SUNDRY NOTICES AND REPORTS ON WELL

5 Lease Serial No NM-15295 6 If Indian, Aflottee or Tribe Name N/A		
5			
r an sals.			
side.	7 If Unit or CA/Agreement, Name and/or N/A		
008	8 Well Name and No. CK FEDERAL # 4		
	9 API Well No 30-015-35942		
	10 Field and Pool, or Exploratory Area WHITE CITY PENN-GAS		
	11 County or Parish State EDDY, NM		
OF NOTICE. I	REPORT. OR OTHER DATA		
F ACTION			
Production (S	tart/Resume) Water Shut-Off

CHANGE IN BOP BECAUSE OF CHANGE IN RIG BEING USED THAN ORIGINALLY PLANNED

BOP SCHEMATIC ATTACHED.

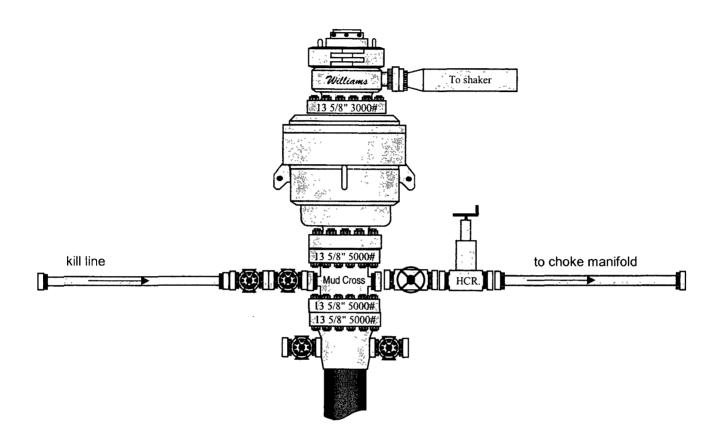
After setting 13-3/8" surface easing, a 13-5/8" x 3M Diverter Stack will be installed to drill the 12-1/4" hole. This will consist or a 13-5/8" x 3M spool (mud cross) with a 13-5/8" x 3M annular preventer and rotating head on top. Upon setting 9-5/8" casing, an 11" x 5M BOP will be installed to finish the hole. This will consist of a 11" 5M spool (mud cross) and 11" 5M double stack with pipe rams and blind rams with rotating head on top.
